SUB-003627-2026

- Subdivision approval to create four (4) legal lots of record from two (2) legal lots of record.

# LARKWOOD MILLER LANE SUBDIVISION

APPLICATION NUMBER 8 DATE March 19, 2026

# DETAIL SITE PLAN

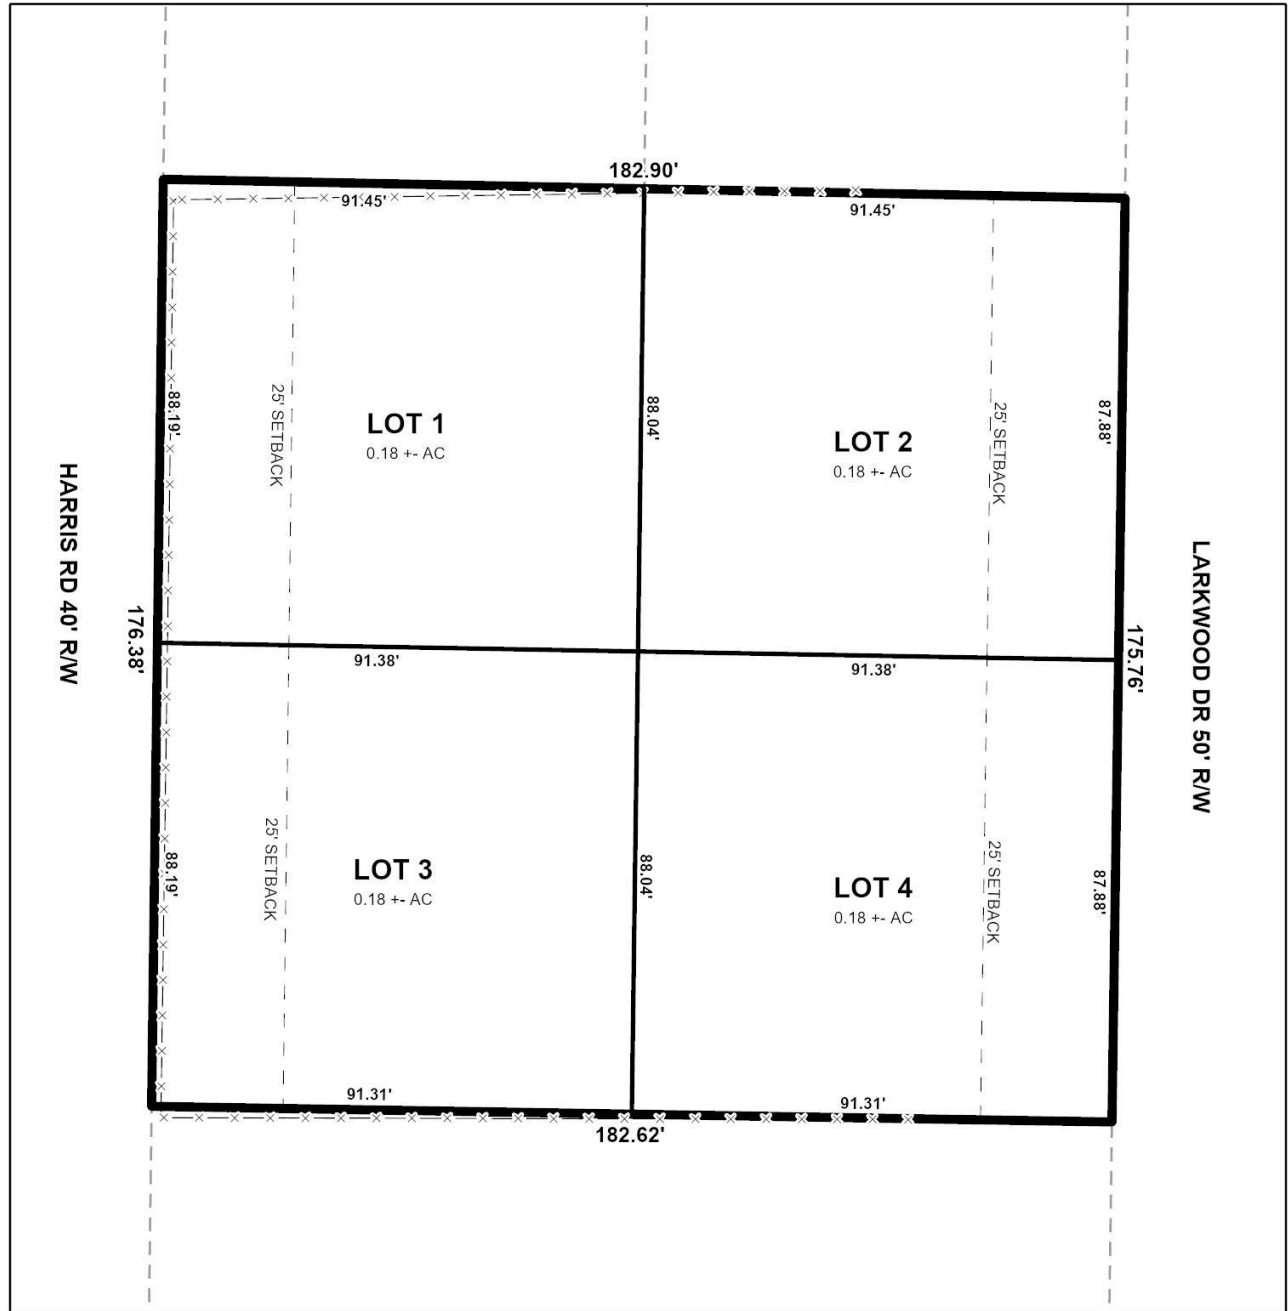
Proposed Lots 2 and 4 have frontage on Larkwood Drive, a minor street with curb and gutter requiring a 50-foot-wide right-of-way, and Proposed Lots 1 and 3 have frontage on Harris Road, a minor street with curb and gutter, also requiring a 50-foot-wide right-of-way. Sufficient right-of-way is depicted along Larkwood Drive on the preliminary plat, but not along Harris Road. As such, if approved, the plat should be revised to illustrate dedication sufficient to provide 25 feet from the centerline of Harris Road, unless a waiver of Section 6.B.9. of the Subdivision Regulations is recommended by the City Engineer and Traffic Engineer

The preliminary plat illustrates a 25-foot front yard setback, in accordance with Article 2, Section 64-2-14.E. of the UDC and Section 6.C.8. of the Subdivision Regulations. If approved, this information should be retained on the Final Plat, adjusted for any required dedication.

1. Retention of the 50-foot-wide right-of-way along Larkwood Drive, as depicted on the preliminary plat;
2. Revision of the plat to illustrate dedication sufficient to provide 25 feet from the centerline of Harris Road, unless a waiver of Section 6.B.9. of the Subdivision Regulations is approved;

3. Retention of the lot sizes in both square feet and acres, or the provision of a table on the Final Plat providing the same information, adjusted for any required dedication;

4. Retention of the required 25-foot front yard setback along all street frontages, in compliance with Article 2, Section 64-2-10.E. of the UDC and Section 6.C.8. of the Subdivision Regulations, adjusted for any required dedication;
